**INDEPENDENT MONITOR AUDIT REPORT –
ENVIRONMENTAL PERFORMANCE OF THE MCARTHUR
RIVER MINE – 2009 OPERATIONAL PERIOD**

**ENVIRONMENTAL EARTH SCIENCES VIC
REPORT TO THE DEPARTMENT OF RESOURCES**

AUGUST 2010

Project: McArthur River Mine Independent Monitor		Job No: 210015
Project Man: GM	Scale: Not to Scale	Figure 3
Drawn By: CM	Date: July 2010

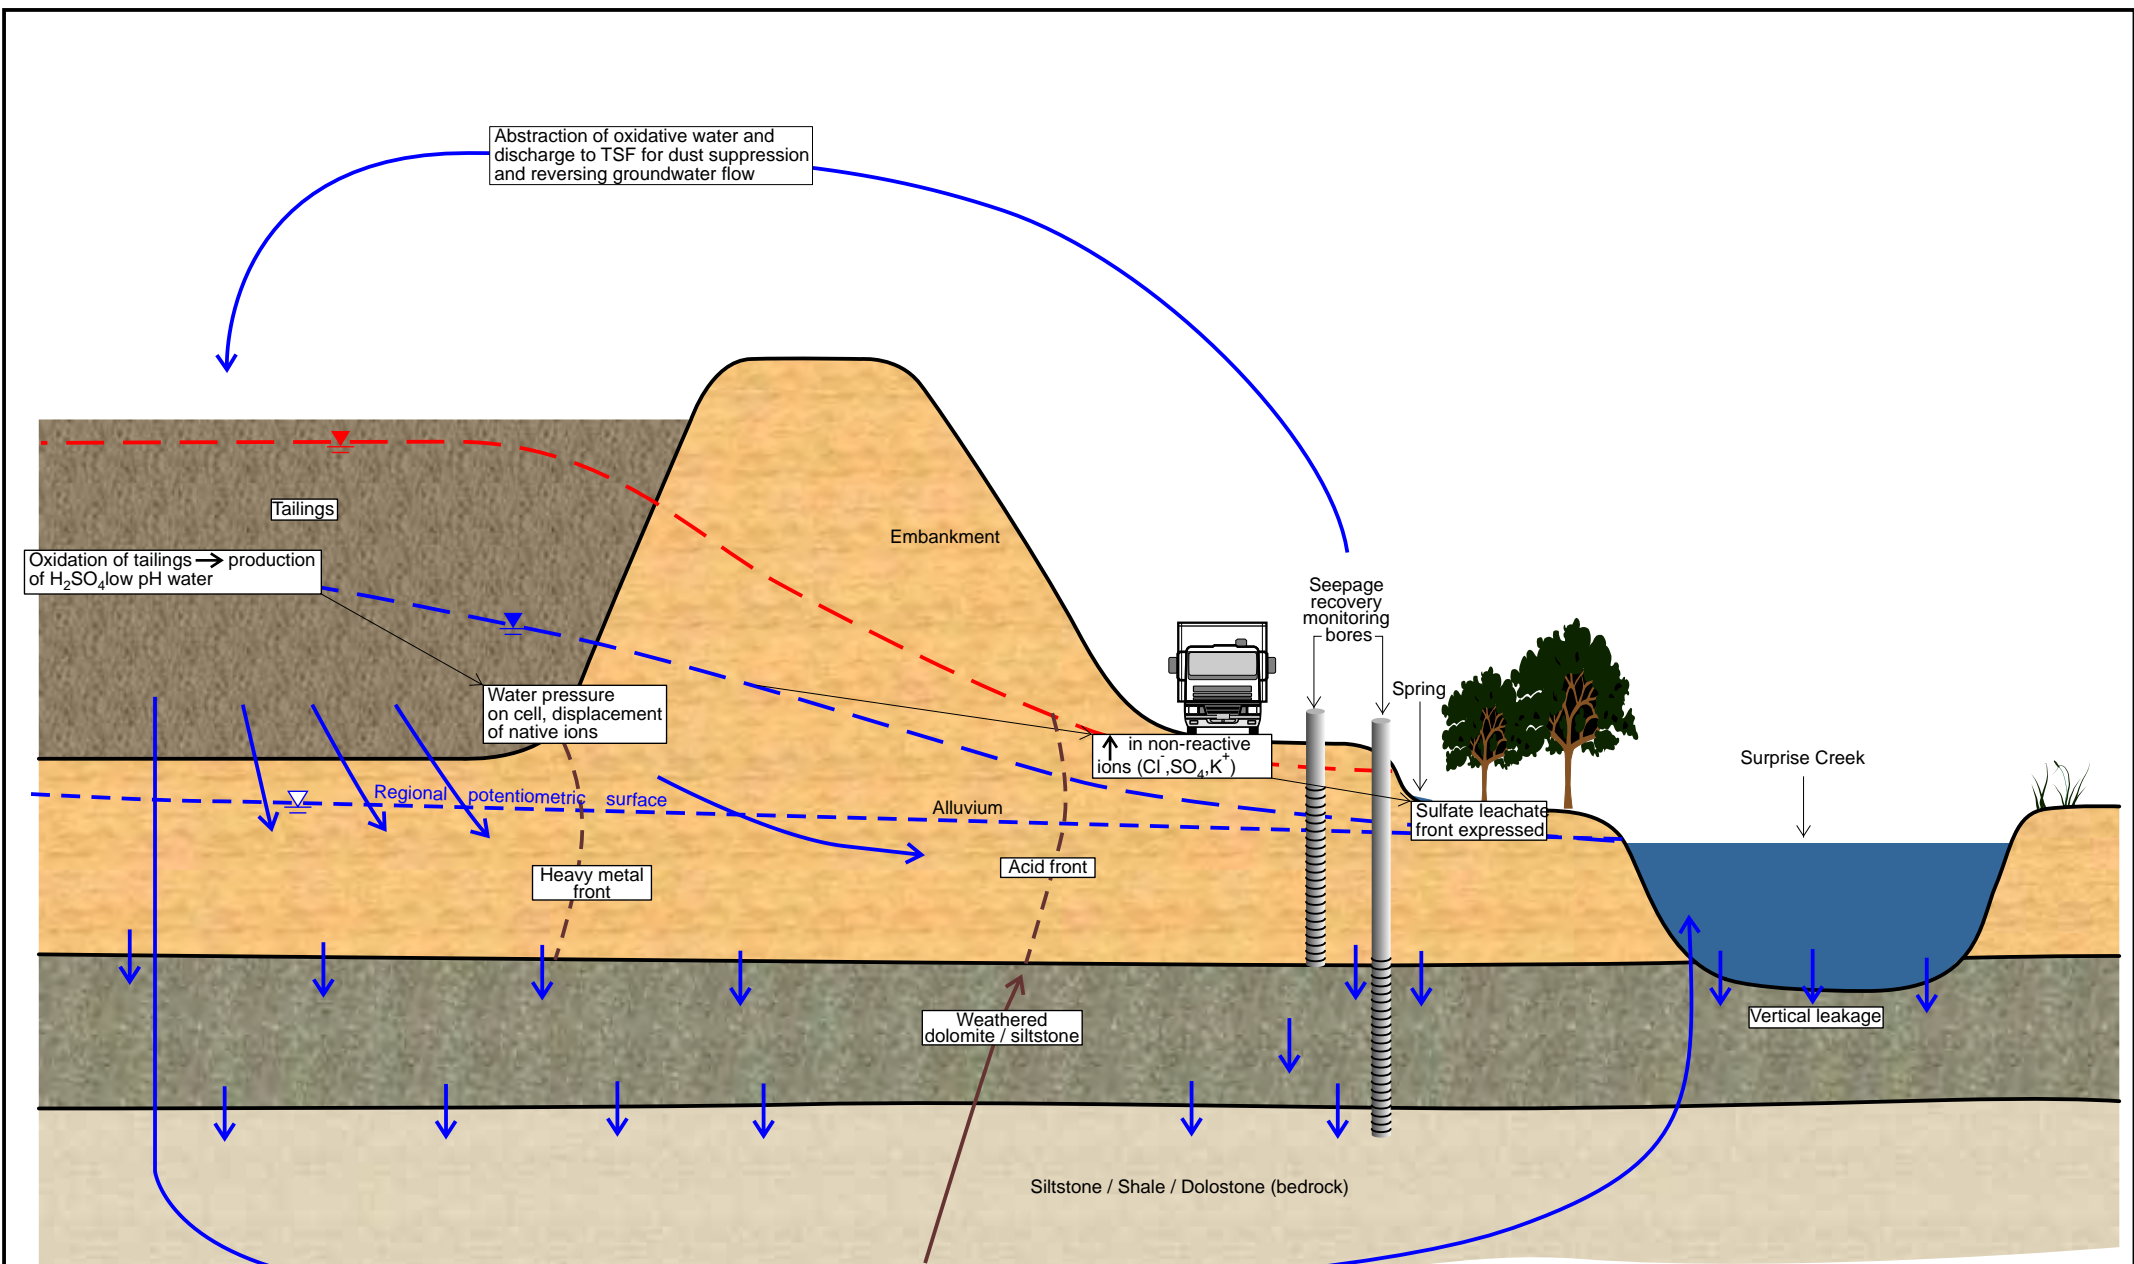
Cell 1 of the Tailings Storage Facility is unlined and in close proximity to Surprise Creek. In June 2009, the Independent Monitor observed leachate migrating from the base of Tailings Storage Facility towards Surprise Creek. The presence of alluvium (sands, sandy-clays and silts) and also potential 'paleochannels' (conductive discrete zones of sands and gravels) is a contributing factor to this leachate migration from the Tailings Storage Facility to the creek, which was known to have occurred within 2 years of commencement of tailings deposition (c. 1997). The potential for migration through the underlying fractured dolomite siltstone is unresolved.

- URS completed a site inspection in February 2010 and report (dated 29 March 2010) (URS, 2010a), aimed at providing final solutions to seepage issues. URS reported that the primary issue concerning the Tailings Storage Facility is the excess amount of liquor being stored at the surface of the Tailings Storage Facility, which is likely to be causing saturation of the dam walls. URS note that the Tailings Storage Facility was not designed to be a water retention dam. URS recommended that the volume of water in the Tailings Storage Facility be reduced to remove the source of infiltration, and leachate should be prevented from reaching Surprise Creek. Recommendations for such mitigation includes:

Plate 35 - Reconstructed sump at the west outer corner of the ROM Pad.

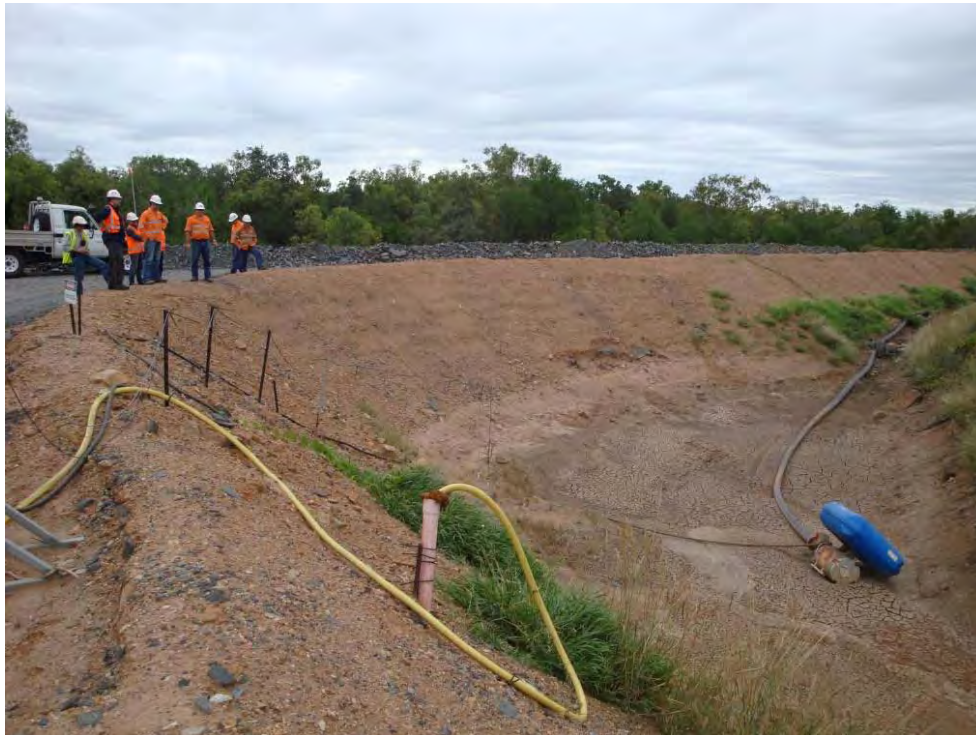
In response to this incident, the sump has been reconstructed (See Plate 35 -) to withhold a larger capacity and thus if the pump fails (as in the previous incident), there would be a longer period of time to address any issues before overtopping occurs. Although the Independent Monitor visually inspected the reconstructed sump, no design calculations were provided to support the assertion that the capacity will be sufficient.

The Independent Monitor has reviewed a capacity calculation and as-built drawings provided by MRM. If pump failure was to occur, we are satisfied that the capacity of the sump is likely to be sufficient to collect and hold runoff until the pump can be replaced or repaired.
